| TITLE - NTPL-183 UPDATED OPENING GA | | | | NIHVA TECHNOLOGIES PVT.LTD.PUNE<br>Website - www.nihva.com |
| | NAME | SIGNATURE | DATE | PROJECT NO - NTPL 183-HP |
| DRAWN | H.B. | | 08.08.2023 | PRODUCT - RETRACTABLE ROOF |

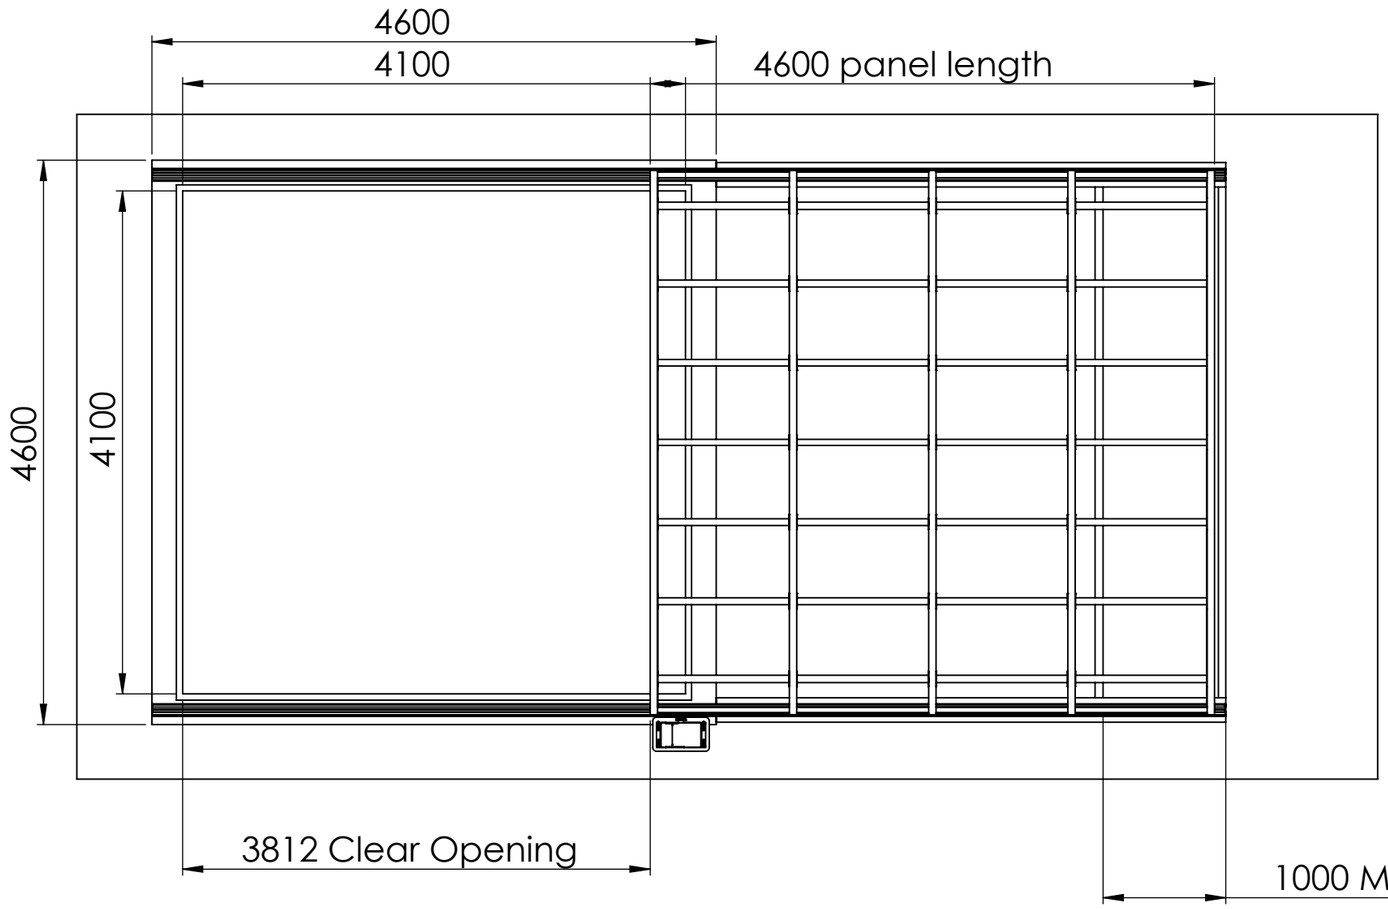
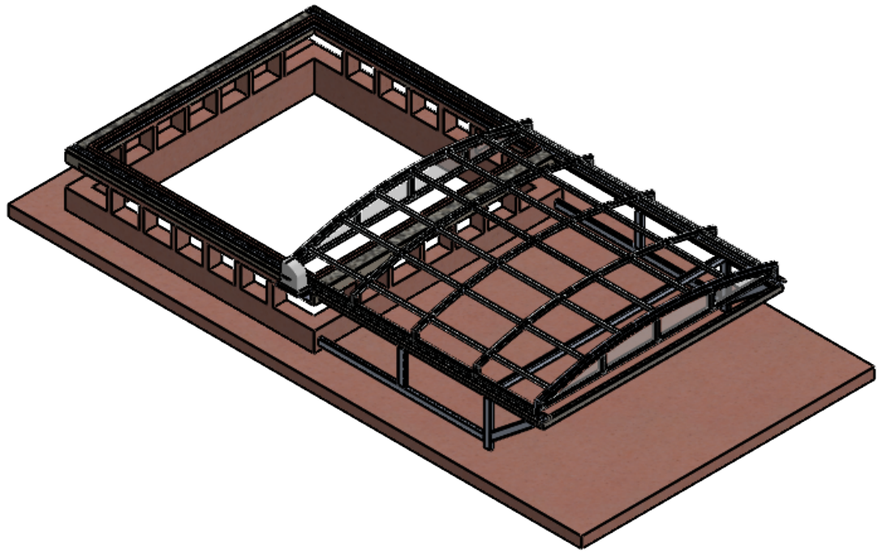
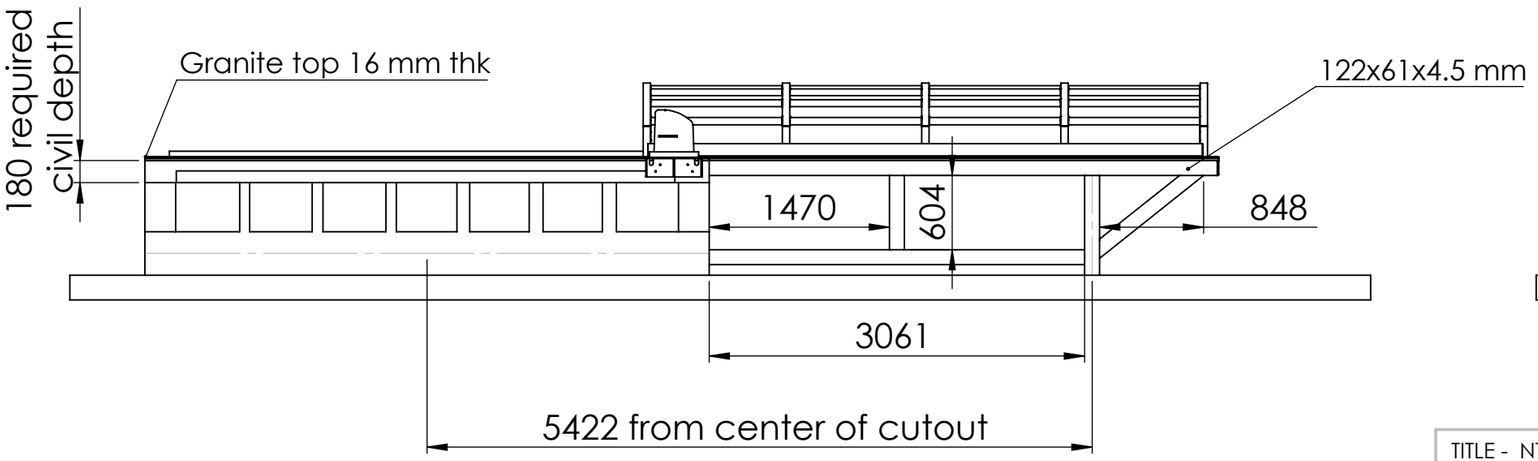
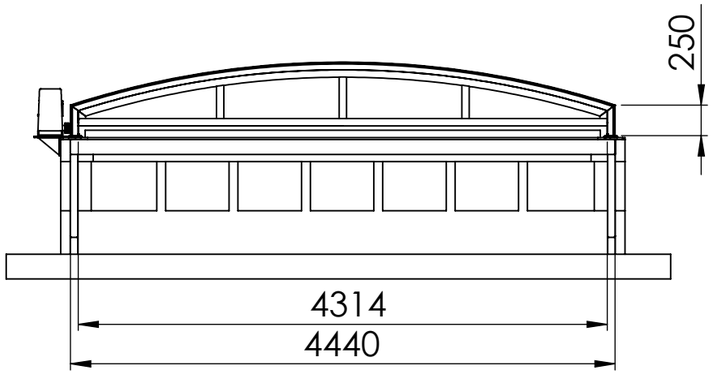
Note :
1) Top civil depth is shown as 100 mm in given autocad drawing and must be increased upto 180 mm for mounting of track
2) top surface shoud be of granite 16 mm thick
3) clear opening is 3812 mm
4) ms plate and granite top surface must be on same level for Track mounting
